**Subject: MHI's Revised Amended Response to US-APWR DCD RAI No.399-2992
Revision 0 (SRP 16)**

MHI's Revised Amended Response to US-APWR DCD
RAI No.399-2992 Revision 0
(SRP 16)

RAI NO.: NO. 399-2992 REVISION 0
SRP SECTION: 16 - TECHNICAL SPECIFICATIONS
APPLICATION SECTION: 16
DATE OF RAI ISSUE: 6/18/2009

QUESTION NO.: 16-298

**Figure 16.298-1 Pressurizer Water Volume vs. Time
Loss of Non-Emergency AC Power (DCD Subsection 15.2.6)**

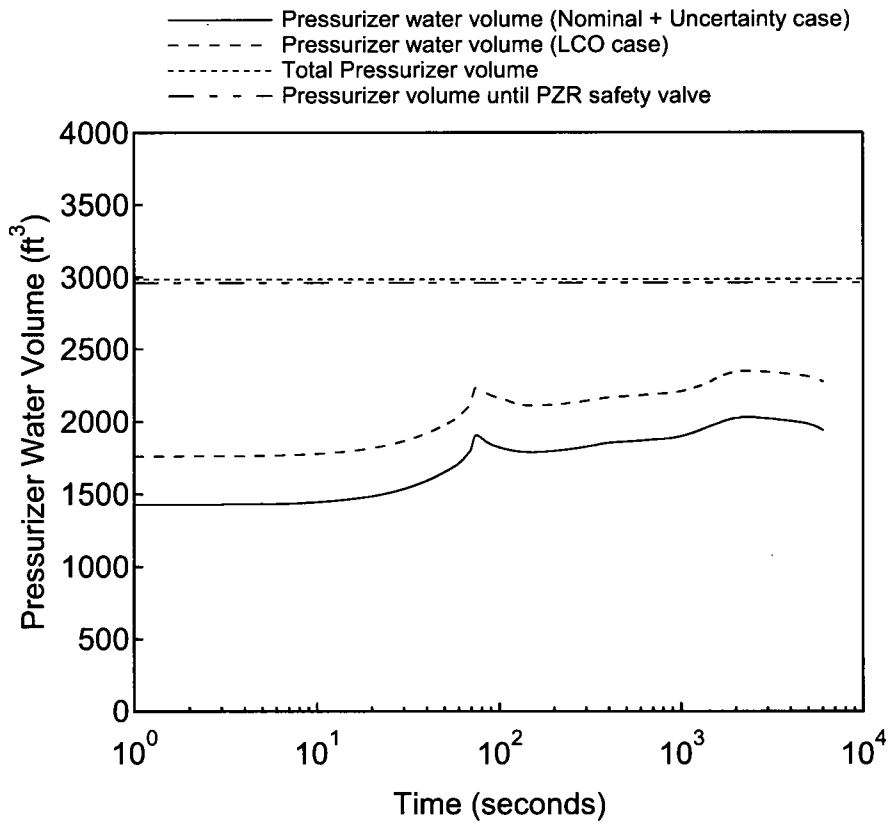
Provide justification for the selected pressurizer water level limit of 92% specified in LCO 3.4.9.a and SR 3.4.9.1. Revise LCO 3.4.9.a, SR 3.4.9.1 and the associated TS bases, as appropriate.

In the APWR DCD Section 15.2, the initial conditions of the pressurizer water volume assumed in all heatup transients are below 1500 cu-ft. (see Figures 15.2.1-4, 15.2.7.4 and 15.2.8-3) which is less than 50% of the total pressurizer water volume (3000 cu-ft). A heatup transient or accident initiated at 92% pressurizer water level constitutes an unanalyzed event which could lead to a water solid pressurizer and liquid release through the pressurizer safety valves.

MHI has reanalyzed the DCD 15.2.6 and 15.2.7 events to include an additional pressurizer overflow case that uses the revised TS LCO 3.4.9 value of 60% as the initial pressurizer water level. The results for the two events are shown below in Figure 16-298.1 and Figure 16-298.2, respectively. In addition, the pressurizer volume figures include a line indicating the volume associated with the physical location of the safety valves. As indicated by the figures, the location of the valves is very near the top of the pressurizer and therefore the line lies just below the maximum pressurizer volume line. The 60% LCO value provides significant margin to either of these lines such that the small difference between the location of the valves and the top of the pressurizer is negligible. This confirms that the possibility of water or two-phase relief from these valves is precluded for these limiting Chapter 15 AOOs and that pressurizer overflow does not occur. The DCD sections for these two events will be revised to include the case starting from the TS LCO 3.4.9 as discussed in the "Impact on DCD" section below.
